**From:** <william.maher@exeloncorp.com>  
**To:** <MTM2@nrc.gov>  
**Date:** 2/13/06 3:55PM  
**Subject:** Draft SAMA RAI Clarification Response

*DRAFT**Oyster Creek RAI Clarification Responses*

### **Clarifications Needed in Oyster Creek SAMA RAI Responses**

Figure 1c-1 Review Process for Oyster Creek PRA Model

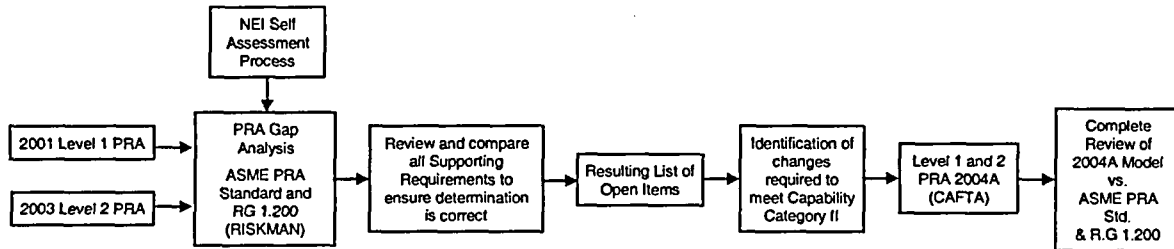
The response to this RAI indicates that the results of the 2004A PRA model were "re-reviewed to establish the number of gaps that remained following the update" and "the self-assessment performed for the 2004A model and documentation also applies to 2004B". Was the 2004A analysis subjected to a complete self assessment or was the focus of the re-review limited to those gaps found in the 2001 PRA? Of concern is the completeness/applicability self-assessment of the 2001 PRA relative to the 2004A model considering the extensive changes from the 2001 model to the 2004 model not the least of which is the change from support state (RISKMAN) modeling to linked fault tree (CAFTA) modeling.

The Oyster Creek 2004A model, documentation, and results were subjected to a complete self assessment to ensure that they reflected the insights from the RISKMAN model and the model changes made during the 2004A model preparation.

ERIN performed the analysis of the "gaps" of the 2001 Level 1 PRA and the 2003 Level 2 / LERF PRA relative to the ASME PRA Standard [1] and the RG 1.200 [2] changes by direct comparison between the Standards and the PRA. The NEI self-assessment process was used as a second check, but was not a primary input. It was used to ensure that no deficiencies that had previously been pointed out continued to persist. The assessment was performed by strict interpretation of the model and documentation compared with the two documents, Ref. [1] and [2].

The 2004A model was explicitly targeted to comply with the ASME PRA Standard. The areas of compliance in the 2001 PRA model were retained and updated using a consistent methodology to meet Ref. [1] and [2].

Following development of the 2004A model, it was then completely re-assessed using the Ref. [1] and [2].

Figure 1c-1 summarizes this process.
